ADDENDUM No. 4

August 11, 2021

Bid Number: **#75-2021**

Subject: West Hickman WWTP
Dewatering Improvements

**SOLIDS HANDLING BUILDING SECOND FLOOR
ELECTRICAL NEW WORK PLAN (ALTERNATIVE NO. 1)**

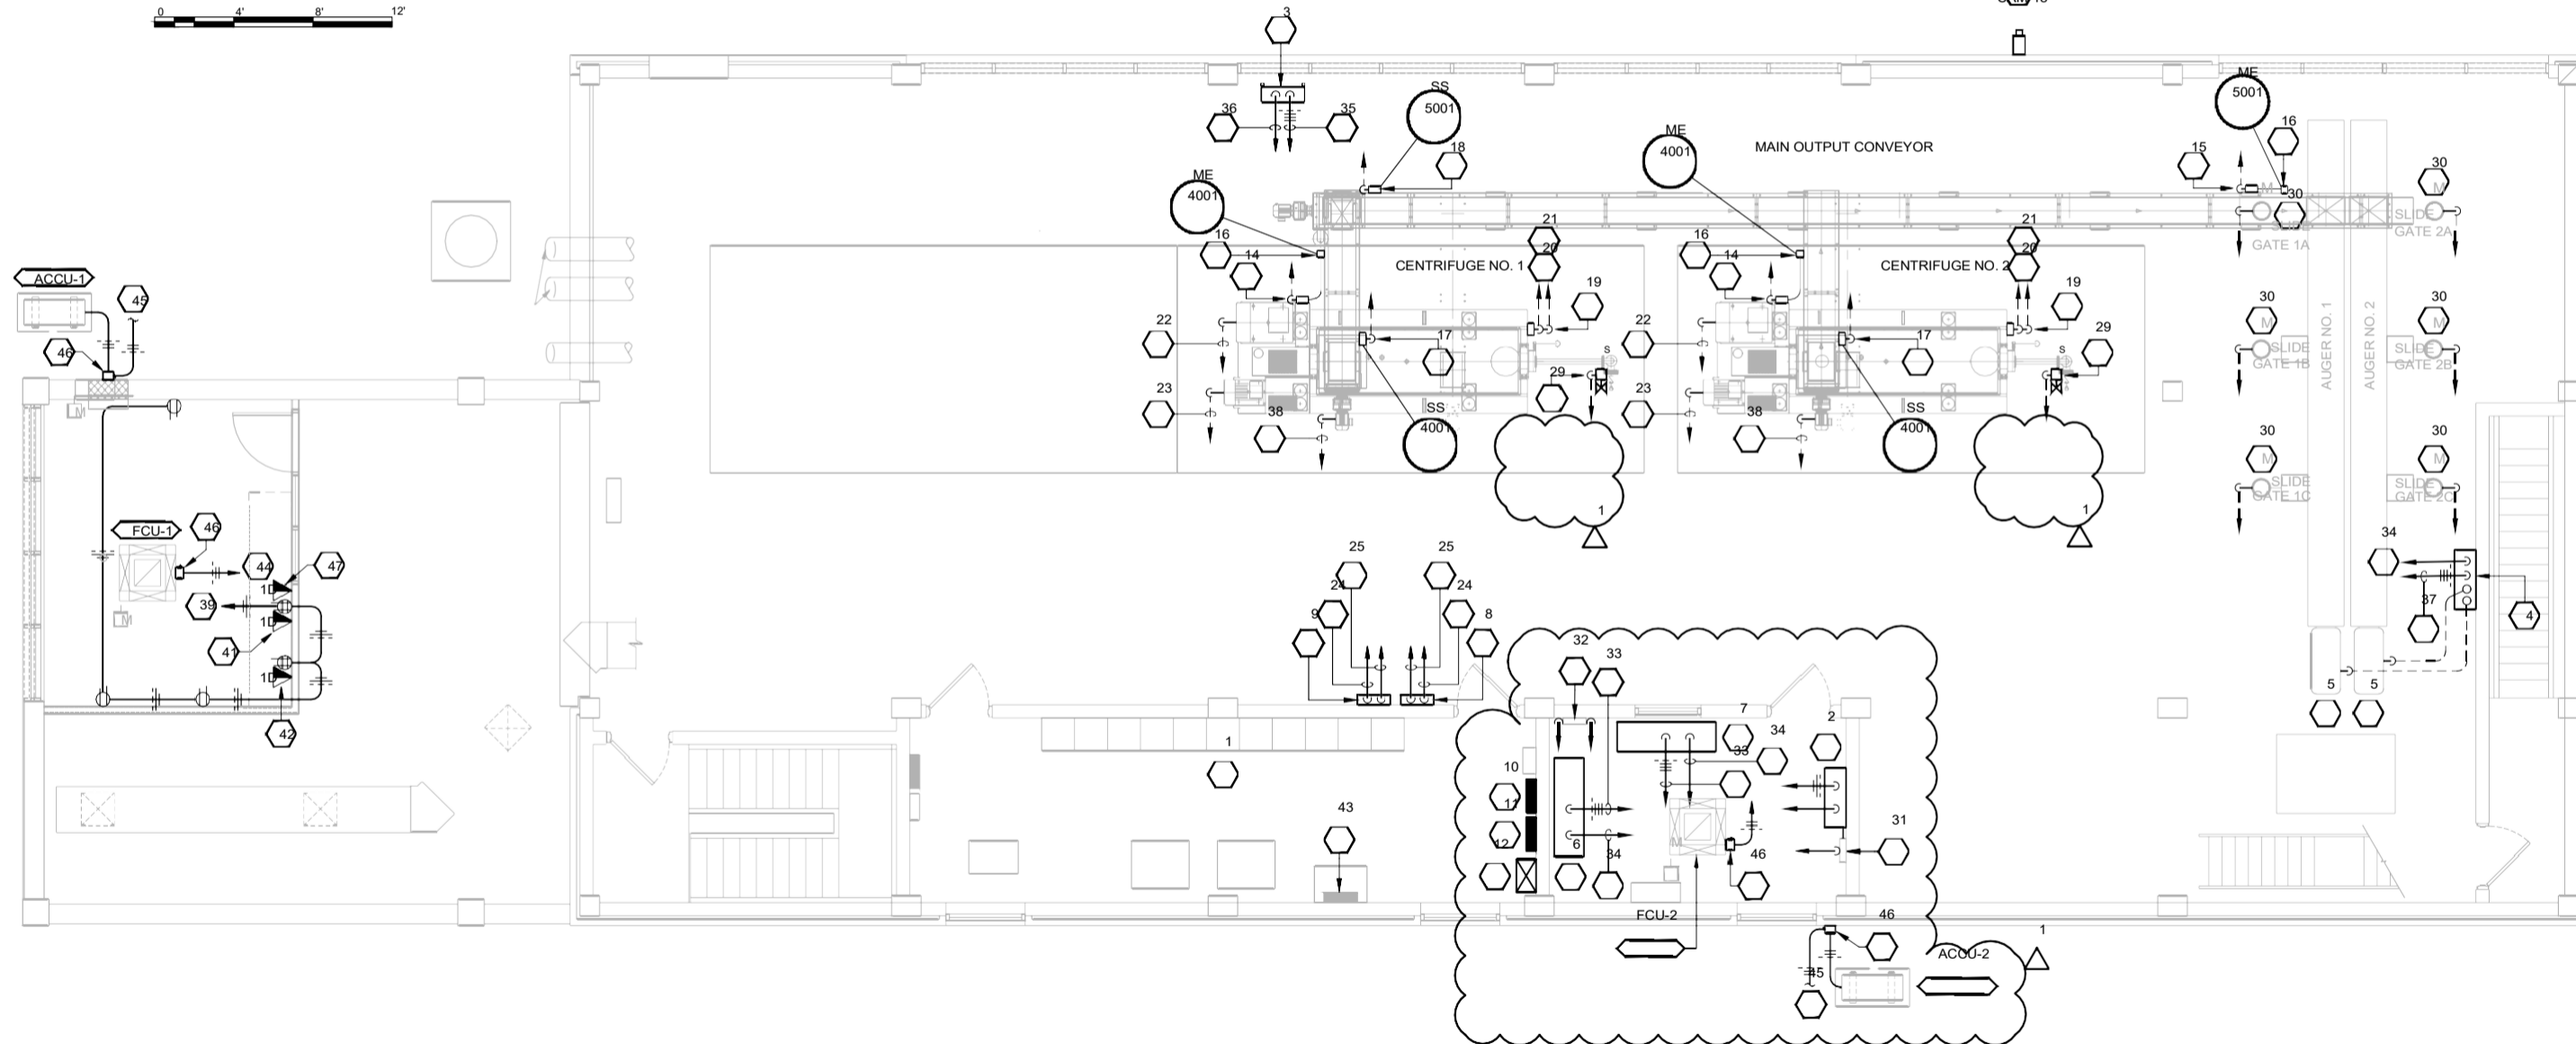
F. Sheet E-01-105

1. Refer to attached drawing, sheet E-01-105, with Addendum No. 4 indicated in the revision section of the border. Note the area(s) shown clouded.
2. Provide electrical equipment and connections as shown for split system FCU-2/ACCU-2.
3. The new auger conveyor control panel shall be fed from the existing auger conveyor circuit breaker in MCC-SPB.

**SOLIDS HANDLING BUILDING SECOND FLOOR
ELECTRICAL NEW WORK PLAN (ALTERNATIVE NO. 2)**

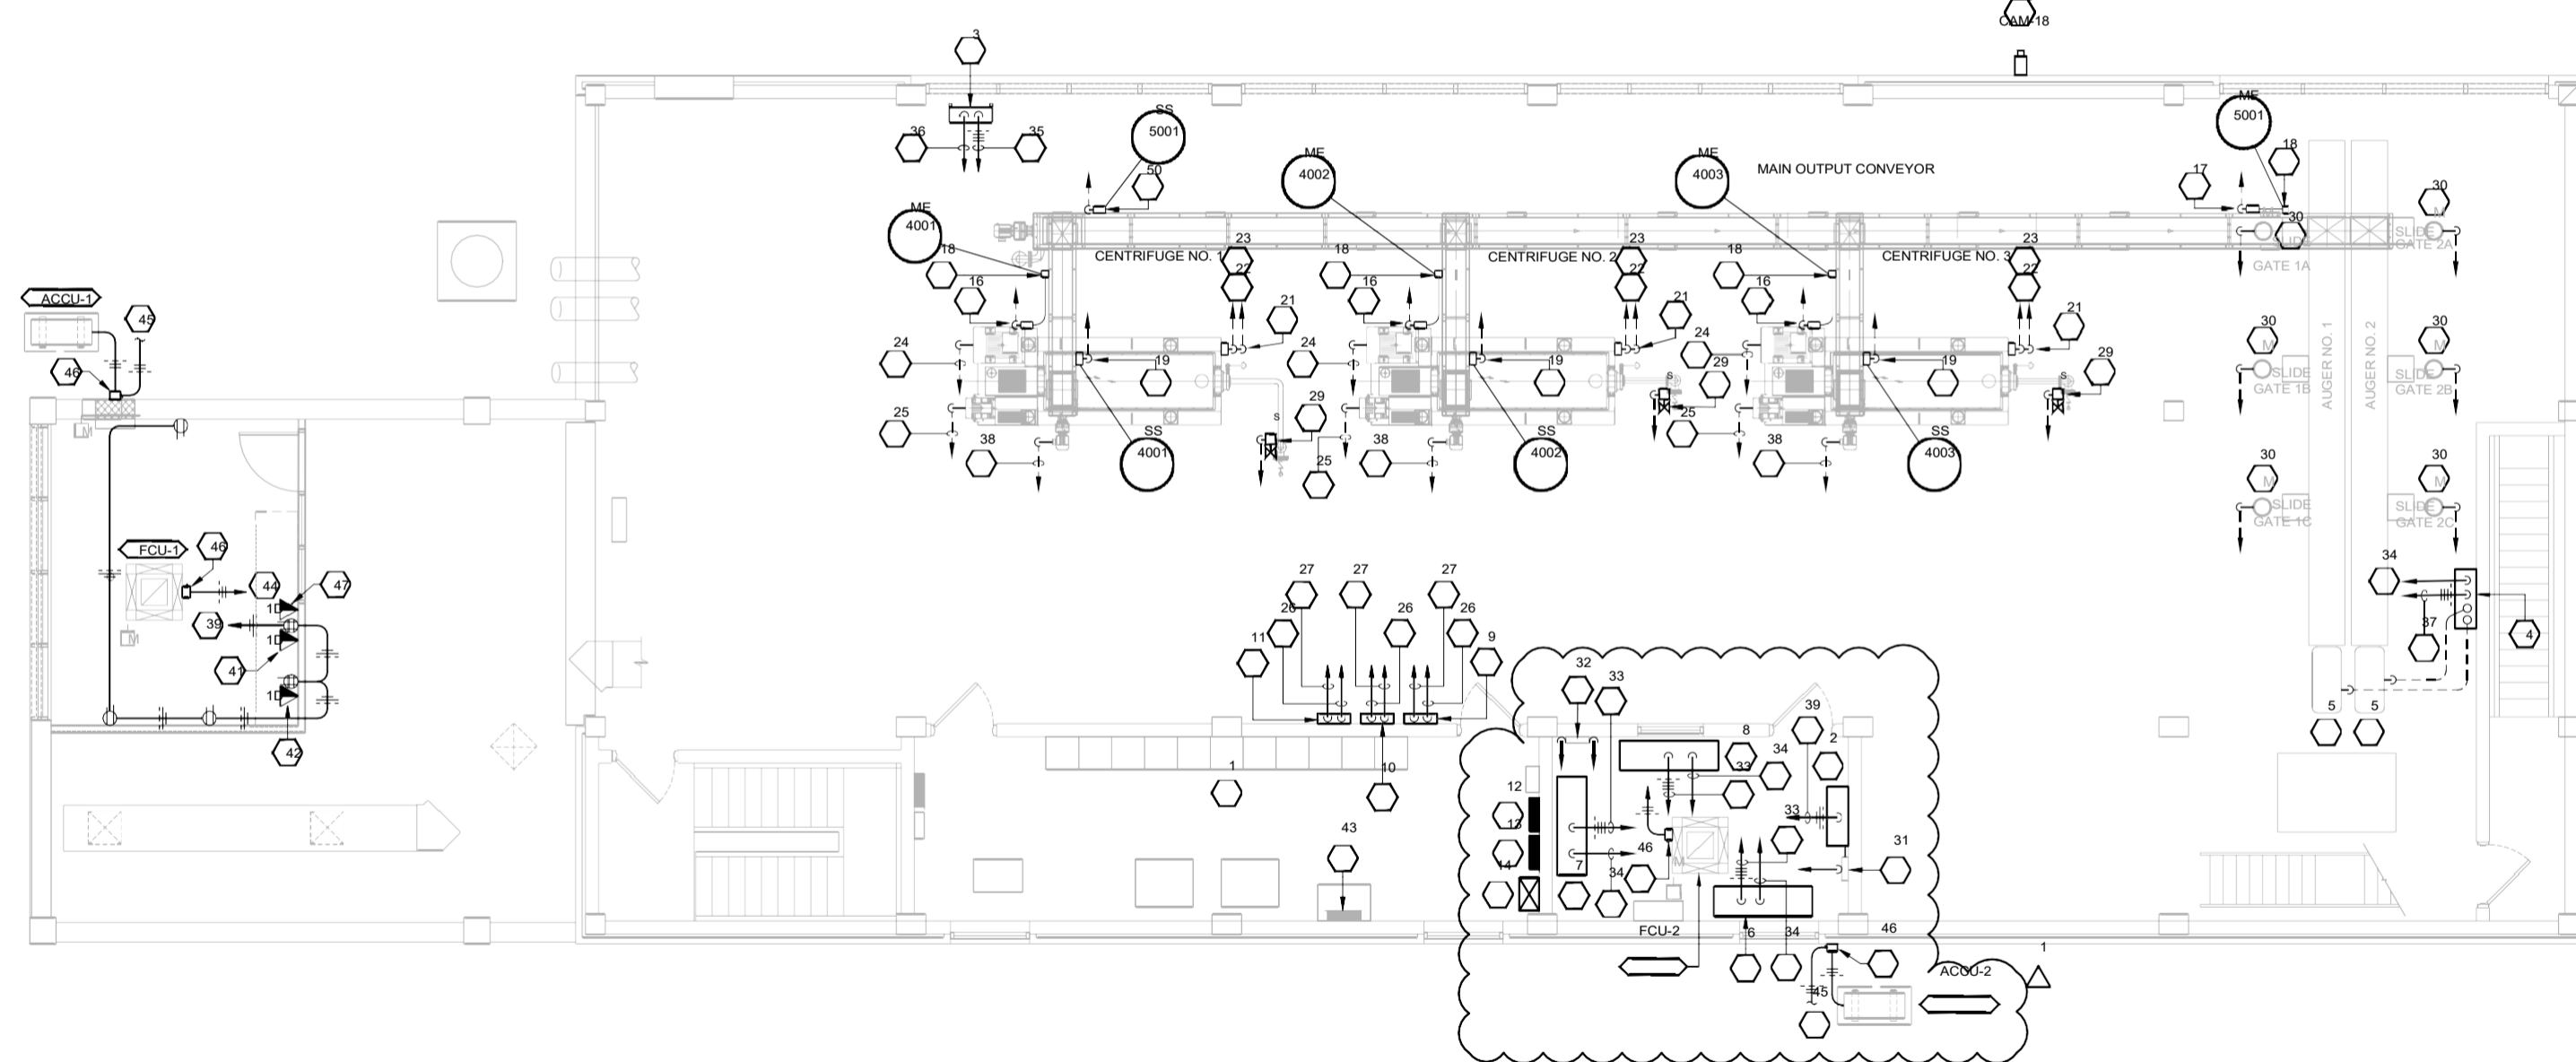
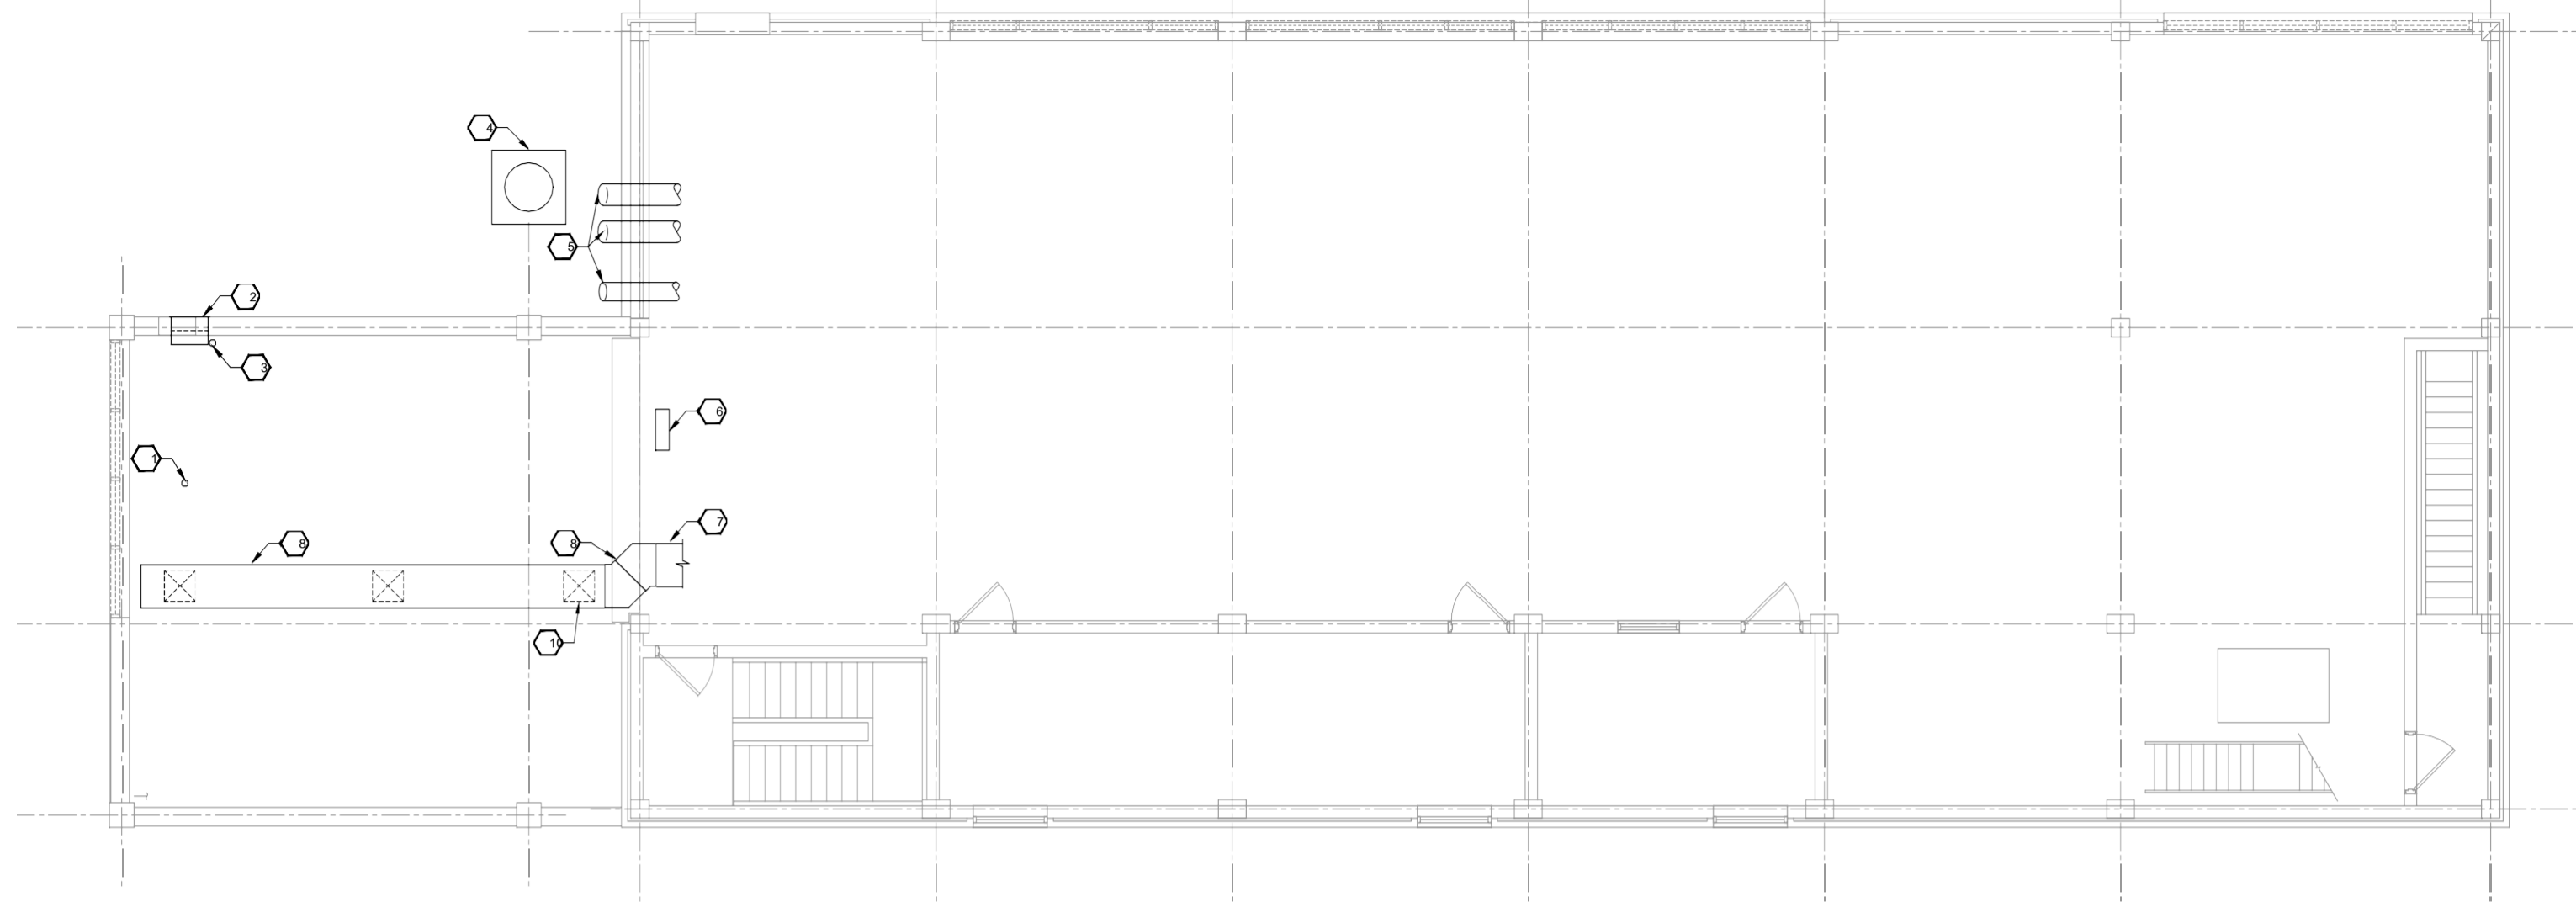
G. Sheet E-01-106

1. Refer to attached drawing, sheet E-01-106, with Addendum No. 4 indicated in the revision section of the border. Note the area(s) shown clouded.
2. Provide electrical equipment and connections as shown for split system FCU-2/ACCU-2. Delete centrifuge air/oil lubrication system and all associated

connections.

3. The new auger conveyor control panel shall be fed from the existing auger conveyor circuit breaker in MCC-SPB.
4. The centrifuge feeder circuit shall be changed to (3)#3/0 and (1)#6 GND in 2" C.

**SOLIDS HANDLING BUILDING
SECOND FLOOR PLANS - HVAC**
 WEST HICKMAN WWTP DEWATERING IMPROVEMENTS
 LEXINGTON-FAYETTE URBAN COUNTY GOVERNMENT

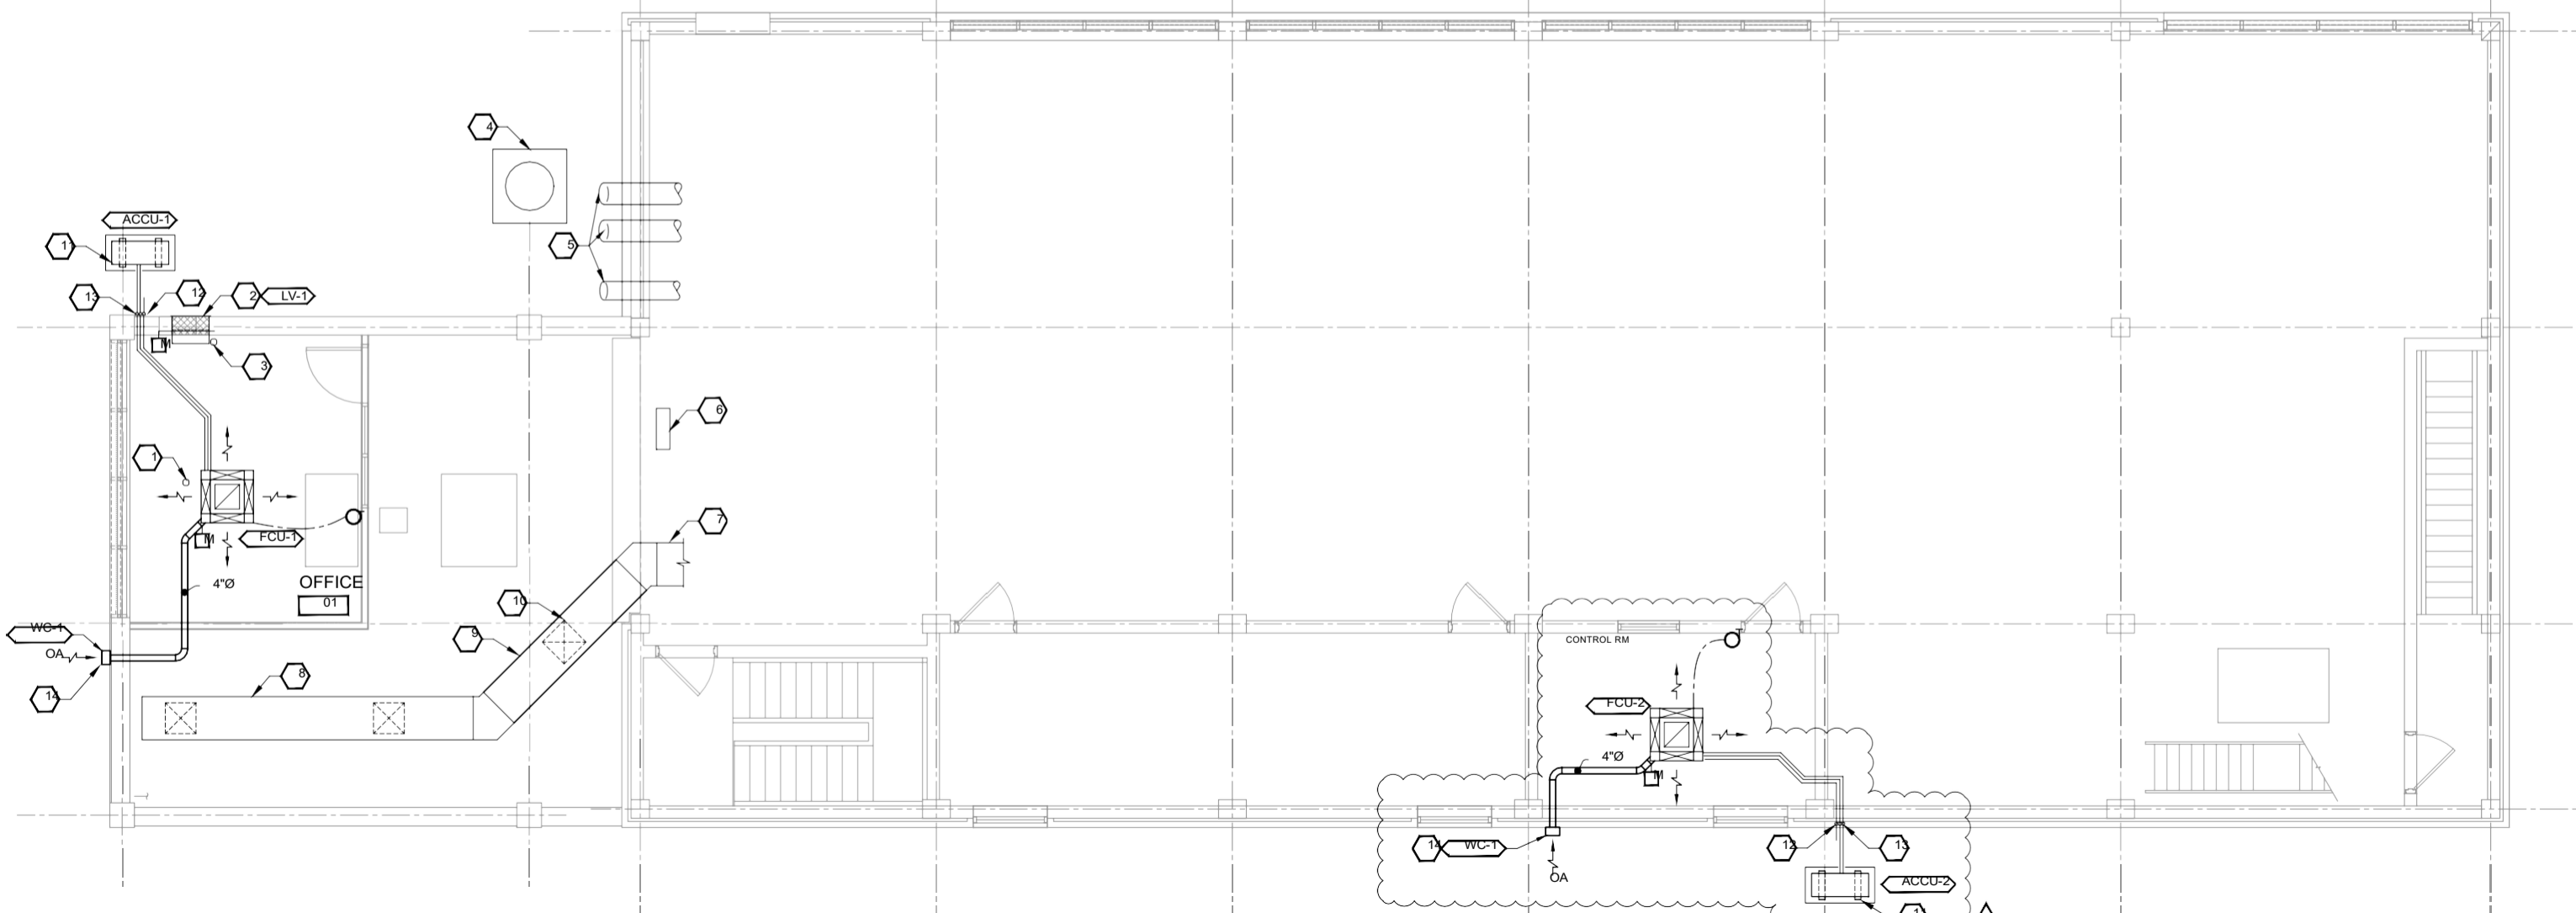
22.	<p>On Sheet A-01-102, Sheet Keynote 3 says, “Existing mechanical louver, blank off w/insulated metal panel. See arch for more information. See mechanical and electrical for req’s of motor removal.”. On Sheet H-01-101, Sheet Keynote 2 says “Existing louver to be abandoned in place. See Arch for more information. Install Louver LV-1 approximately 10-11 feet A.F.F. in the space above the glass wall.” On Sheet E-01-102, Sheet Keynote 15 says “Disconnect existing motorized damper for relocation by others. Reroute existing circuit to new location and re-connect as required. See H-Series drawings for more information.”</p> <p>At this time, we feel:</p> <ol style="list-style-type: none"> a. The note on Sheet A-01-102 is correct. b. The highlighted part of the Note on the H-Drawing-1-101 appears to be incorrect. Why would an FRP louver with a motorized damper be installed in an air-conditioned space? c. Additionally, there is not a glass wall at that location. The highlighted portion of the E-drawing note appears to be incorrect. <p>Please review these comments and respond\clarify as necessary.</p>	<p>The drawings and specifications are correct. The existing louver shall be abandoned in place. The existing louver shall be “blanked off” to provide a cover for the existing louver. Damper shall be disconnected. LV-1 shall be installed through the wall 10’ to 11’ above the floor and above the existing louver. The glass wall refers to the adjacent glass partition. LV-1 shall then ventilate the remainder of the storage area, above the ceiling of the office. The electric power supply for the existing damper shall be rerouted to the LV-1.</p>

H. Sheet H-01-101, H-01-501, M-01-103

1. Replace these sheets in their entirety with the attached drawings.
